- 2. Anglers Crest Subdivision 2024 Addition; KPB File 2024-019
Johnson Surveying / Ninilchik Native Association, Inc.
Location: Shavila Road, Matrona Drive & Kimeluk Street
Happy Valley Area**

**ITEM #2 - PRELIMINARY PLAT
ANGLERS CREST SUBDIVISION 2024 ADDITION**

KPB File No.	2024-019
Plat Committee Meeting:	March 25, 2024
Applicant / Owner:	Ninilchik Native Association Inc
Surveyor:	Jerry Johnson / Johnson Surveying
General Location:	Ninilchik along Sterling highway near Deep Creek Road

Anglers Crest Subdivision 2024 Addition PRELIMINARY PLAT

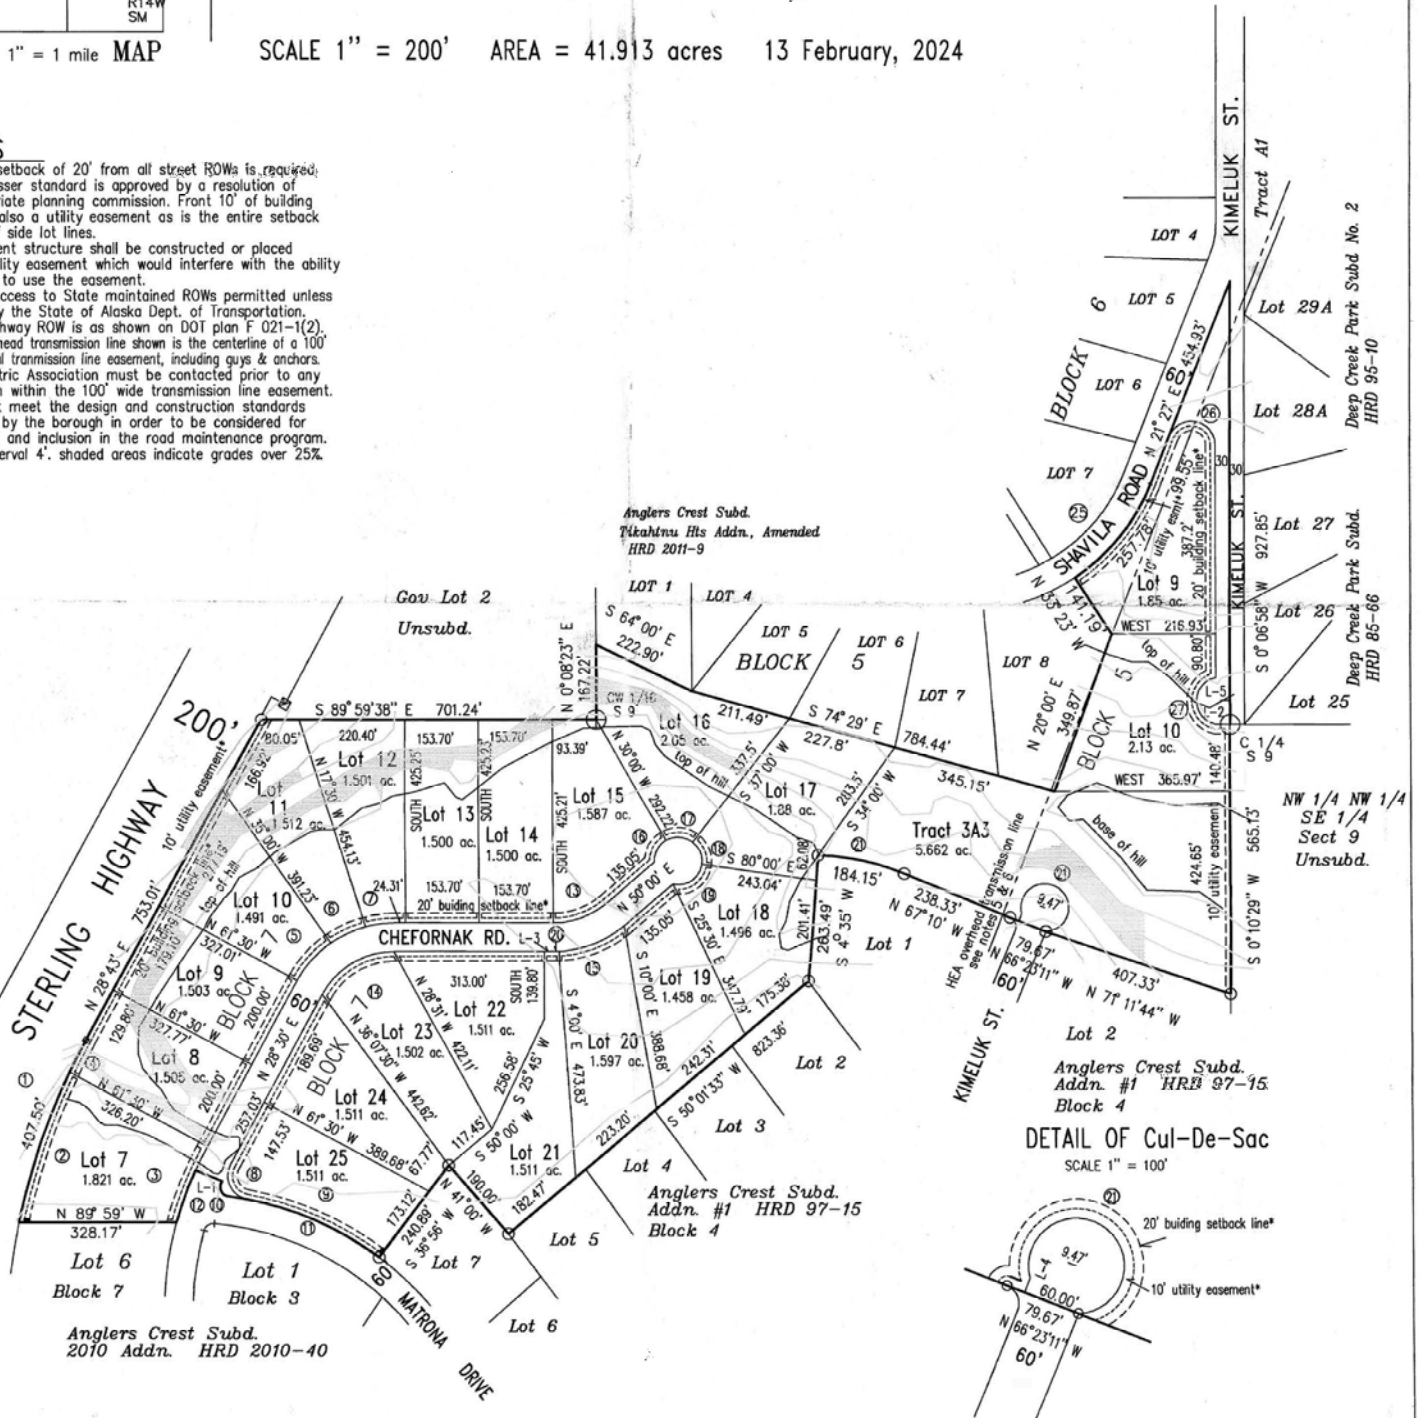
There are some steep areas shown on the plat by the shaded areas drawn on the plat. The slopes are mostly on the edges of this plat. Contours are shown but there are no elevations given. The label on the east shown as 'base of hill' is deceptive as to where is the hill located. With elevations or added flowage arrows this could help to show the direction of the hill location.

- Add KPB File No 2024-019 to title block.
 - Add name and ROW to road to southwest.
-

- D. A vicinity map, drawn to scale showing location of proposed subdivision, north arrow if different from plat orientation, township and range, section lines, roads, political boundaries, and prominent natural and manmade features, such as shorelines or streams;
Staff recommendation:
Add roads and names to map to get to site.

- G. The status of adjacent lands within 100 feet of the proposed subdivision boundary or the land status across from any dedicated rights-of-way that adjoin the propose subdivision boundary, including names of subdivisions, lot lines, block numbers, lot numbers, rights-of-way; or an indication that the adjacent land is not subdivided;
Staff recommendation:
Add block labels to the lots to the southeast of the plat

- L. Contours at suitable intervals when any roads are to be dedicated unless the planning director or commission finds evidence that road grades will not exceed 6 percent on arterial streets, and 1 0 percent on other streets;
Staff recommendation:
Contours are shown but there are no elevations given. The label on the east of 'base of hill' is deceptive as to where is the hill located. With elevations or added flowage arrows this could help.
-

HEA REVIEWED - SEE COMMENTS

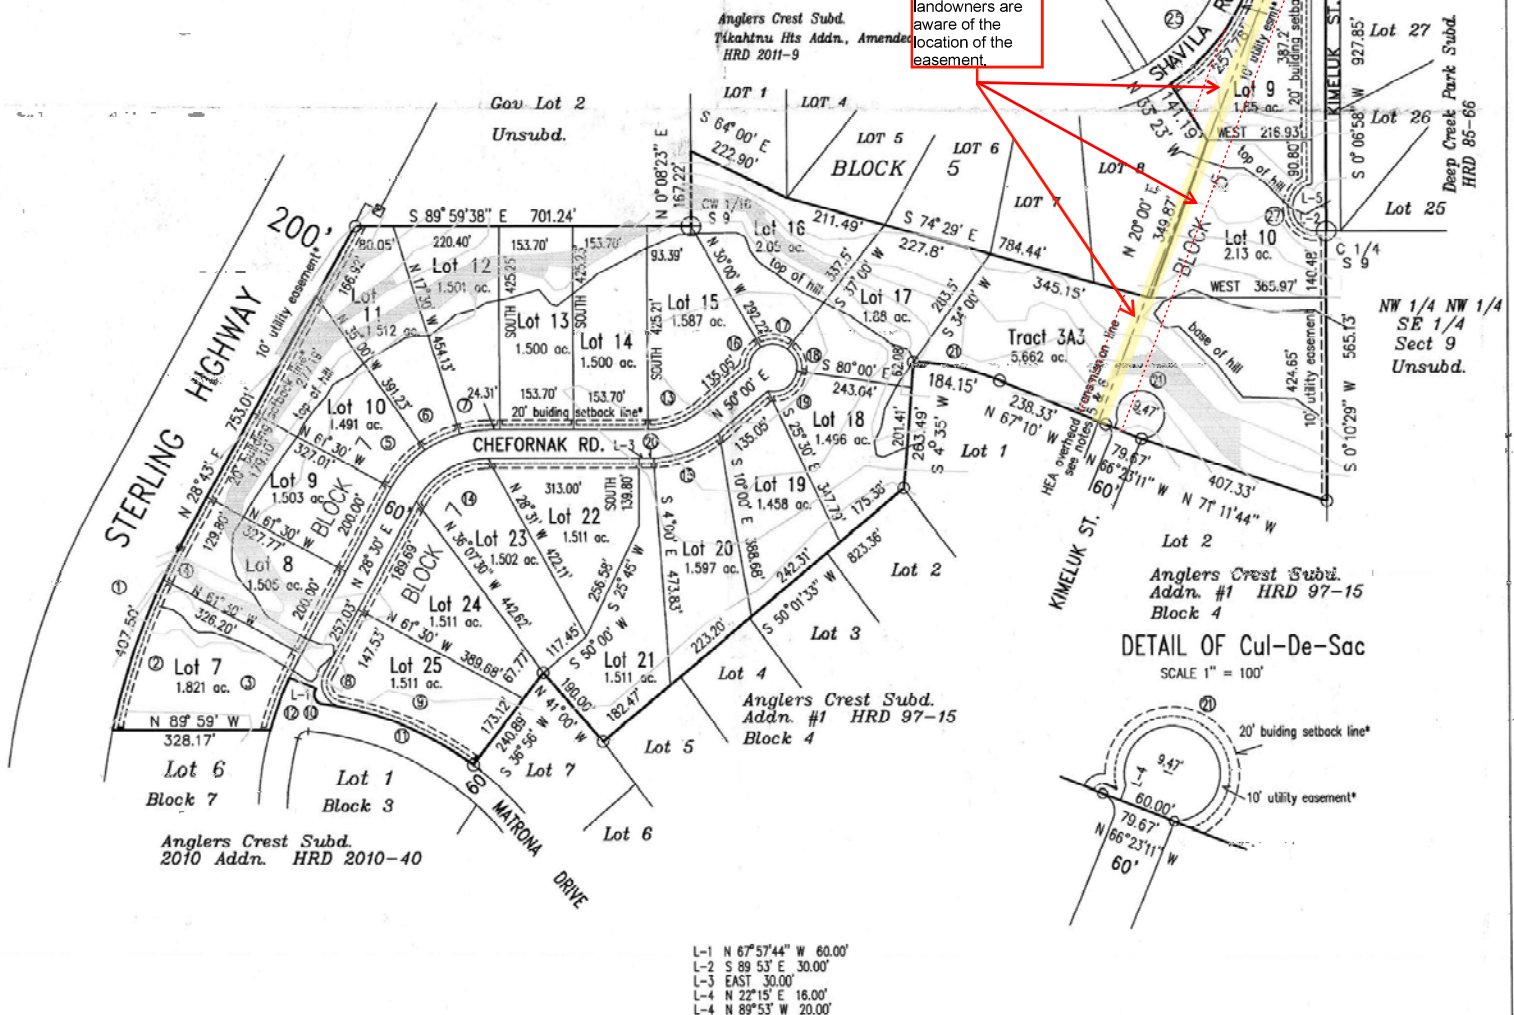
The standard plat note for a transmission line is as follows: "The existing overhead electric transmission line is the centerline of a 100-foot-wide electrical transmission line, including guys and anchors, granted this plat. Construction of public roads shall be restricted to the outer 20 feet of one side or the other, but not both sides of the easement. Public roads or driveways crossing the easement shall be located as nearly perpendicular to the transmission line as is reasonably possible. No portion of a road or driveway shall be closer than 25 feet to a transmission line pole/structure. No excavation or fill within the easement is allowed without the express written permission of HEA."

Plat notes 5 and 6 are acceptable to HEA and the surveyor can either use current plat notes 5 and 6 or the plat note provided by HEA.

Please show the limits of the 100 foot wide transmission line easement so landowners are aware of the location of the easement.
